IFB No. **23-37 Security Vestibules at Flinn, Guilford, Lincoln, Nashold & Summerdale Schools**

RE: **ADDENDUM NO. 1**

ADDENDUM ONE

Project: **SECURITY VESTIBULE AT
VARIOUS SCHOOLS FOR
ROCKFORD PUBLIC SCHOOL DISTRICT #205
ROCKFORD, ILLINOIS**

PROJECT INFORMATION		SHEET IDENTIFICATION	
Date	January 10, 2023	LINCOLN MIDDLE SCHOOL REMOVAL PLAN	
Rev. Date			
RLJA Proj	2022-052	SHEET NUMBER	
		C105

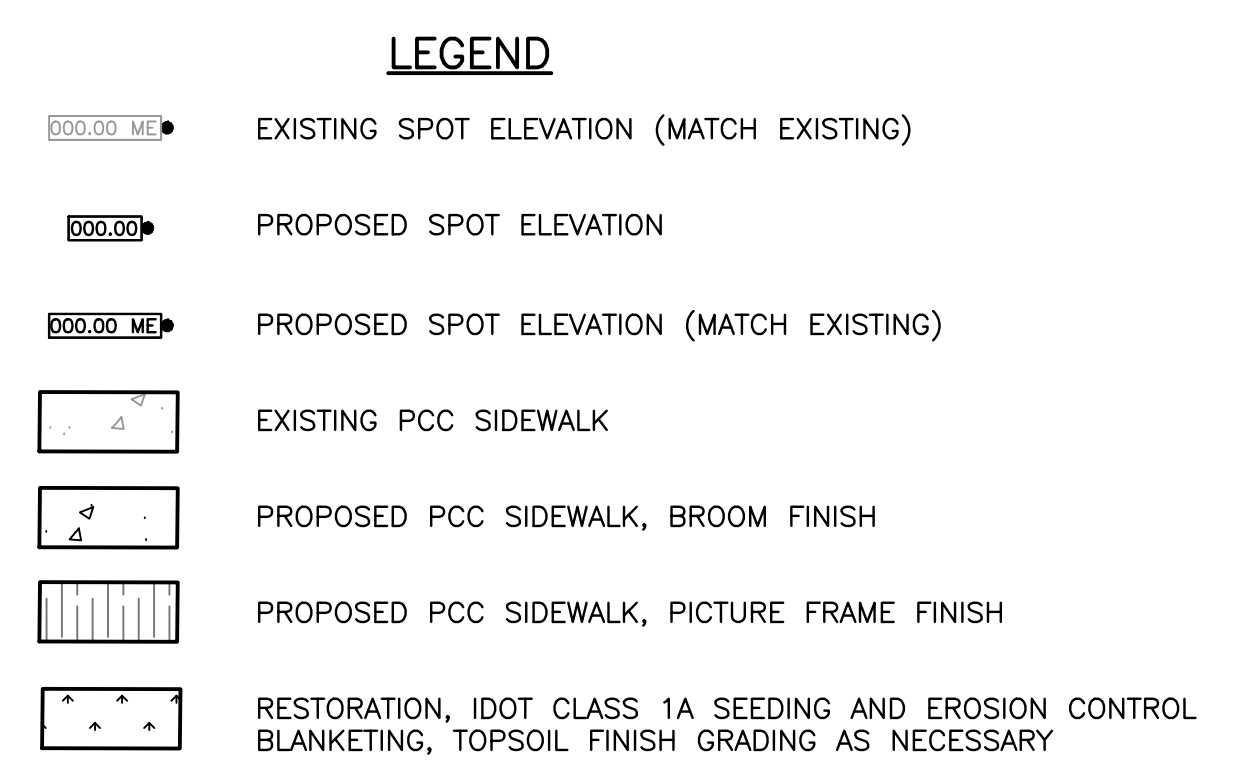
3.1. See added civil drawings for Lincoln Middle School. The exterior railings shall be powder coated.
